TOLEDO - LUCAS COUNTY PLAN COMMISSIONS

REF: SUP-11004-21

SUBJECT: Request for Special Use Permit for a propane station, CDL driving pad, & bus storage at 222 McTigue Dr.

SITE PLAN

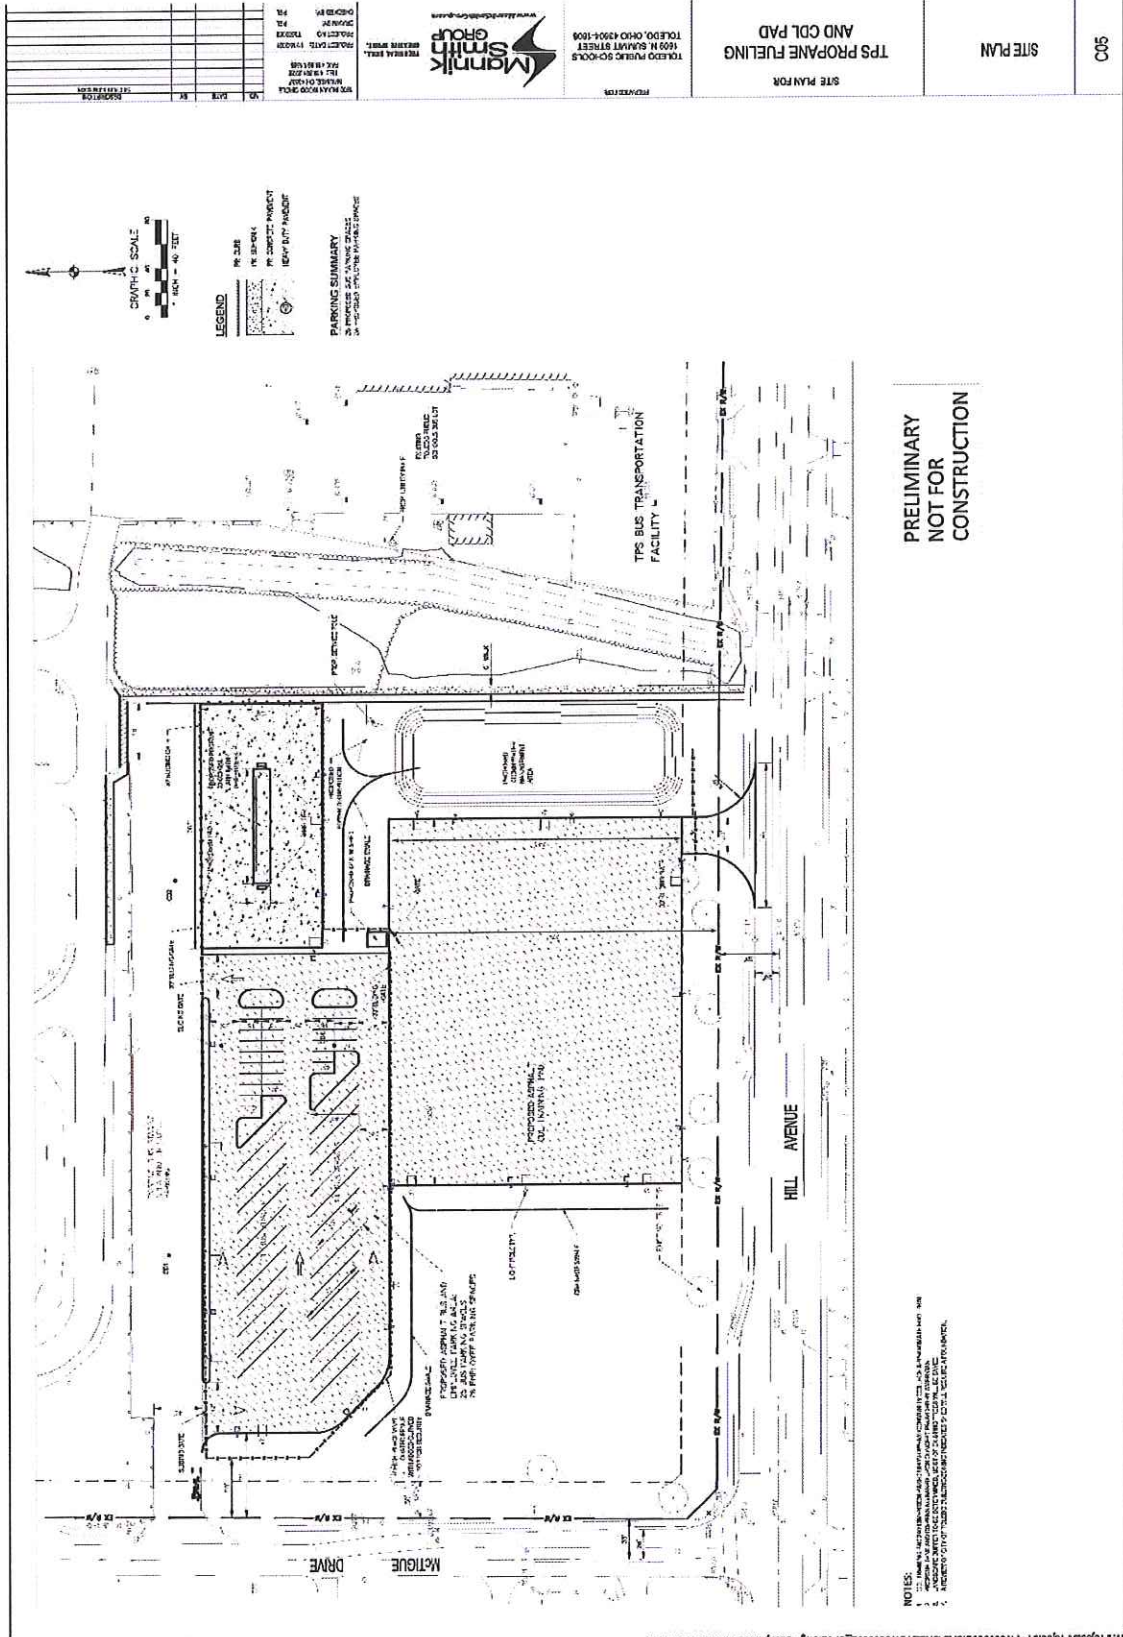
4. Required permits for all approved work in the public right-of-way shall be obtained, before work begins, from One Stop Shop, (419) 245-1220.
5. The existing private fire line located east of the proposed storm water management area and west of Deline Ditch shall be shown on the plans.

6. Maintain a minimum of 18 inches of vertical clearance between the existing fire line and the proposed storm sewer.
7. Verify that the existing fire hydrant located just north of the existing Rogers High School Entrance Drive is connected to an operational fire line. Contact the City of Toledo Fire Prevention Bureau (419-245-1263) to verify the fire protection requirements for this site.

25. A minimum of One (1) van accessible spaces shall be provided on a revised site plan TMC§1107.1701. **Not acceptable as depicted.**
26. Any spaces reserved for the use by persons with physical disabilities shall adhere to the standards outlined in TMC§1107.1700.

29. A minimum of one litter receptacle shall be provided near the employee parking area. **Not acceptable as depicted, none provided.**
30. The relocated pedestrian walkway shall be designed in such a way as to be fully accessible to people with physical disabilities.

- b. The solid evergreen hedge plantings shall be extended eastward along Hill avenue to also screen the storm water management and sliding gate from the sidewalk and road way. **Not acceptable as depicted**

- g. The thirty (30) instances of *Euonymus alatus* 'Pipzam' (Pipsqueak Burning Bush) shall be replaced with a non-invasive alternative. **Not acceptable as depicted.**

- l. The location, height, and materials for any fencing to be installed and maintained; Pursuant to TMC§1105.0402(A)(1), fences may not exceed three and a half feet (3.5') in height in the required front setback. **Location acceptable as depicted. Discrepancy between six-foot (6') and seven-foot (7') fence on spec-sheet and site plan shall be clarified.**
